HAYS CORNER PLAT

SUMMARY

<p>Owner Mark McAuliffe</p> <p>Applicant Abraham Remchuk, Tinklepaugh Surveying Services</p> <p>Project Planner Michaëlle Petion</p> <p>Updated: March 31, 2015</p>	<p>Property Location: 2814 Lake Shore Dr. (South of the intersection of Dorchester St. and Lake Shore Dr.; 18-22-30-0000-00-003) (±0.96 acres, District 3).</p> <p>Applicant's Request: Minor Subdivision request for a 1 lot plat and tract for the construction of a new single family residence.</p>	<p>Staff's Recommendation: Approval of the request, subject to the conditions in this report.</p>
---	---	--

BOUNDARY SURVEY

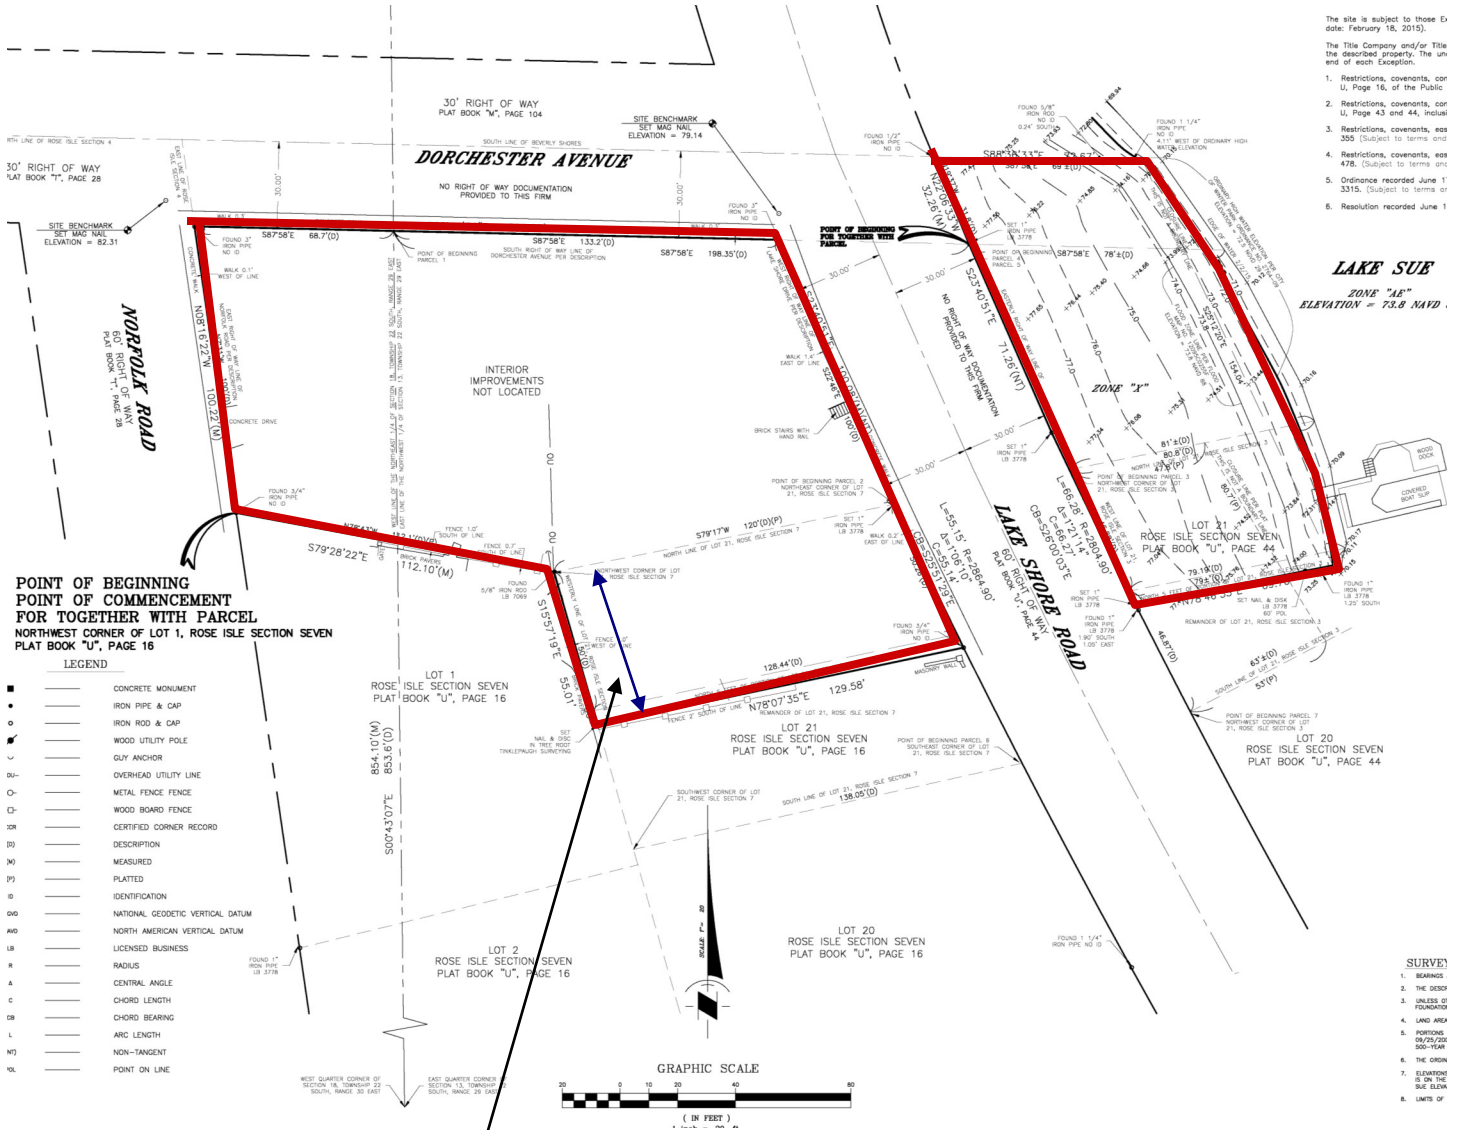
1. Sheet: (Survey) The unplatted portion with lot 21 doesn't show all improvements with elevations.
2. Sheet (Survey) The east and west sides of lot 21 are missing the dimensions.

3. Sheet (Survey) The whole Dorchester Ave. R/W needs to shown and referenced, with the remnant parcel @ the NE.
4. Sheet: (Plat) The Plat Certification Report doesn't state that all mortgages as being not satisfied or released of record of record nor other terminated by law.

PROPOSED PLAT

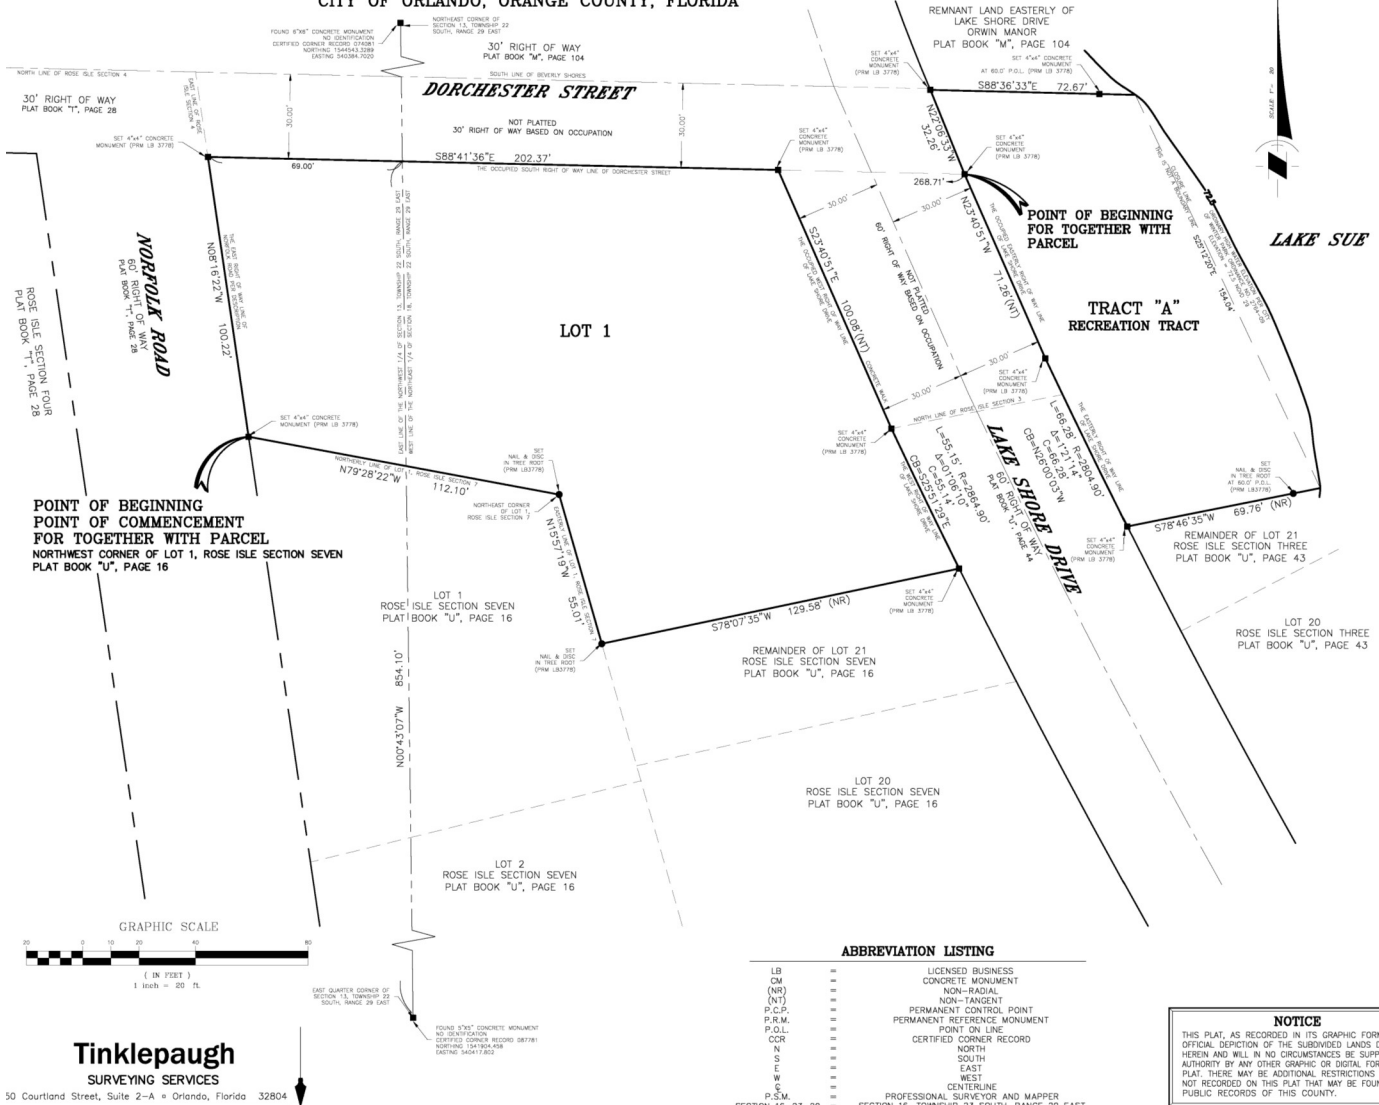
5. Sheet: (Plat) The streets have been dedicated by the previous plats and if there's no other dedication to be made that needs to be stated as such.
6. Sheet: (Plat) The full R/W reference and location is missing.

1. The notary block must provide notarization of both signatures.
2. All existing easements must be shown on the plat or in the plat notes. The plat certification report indicates there may be easements within the deeds recorded in 88/355, 222/478.
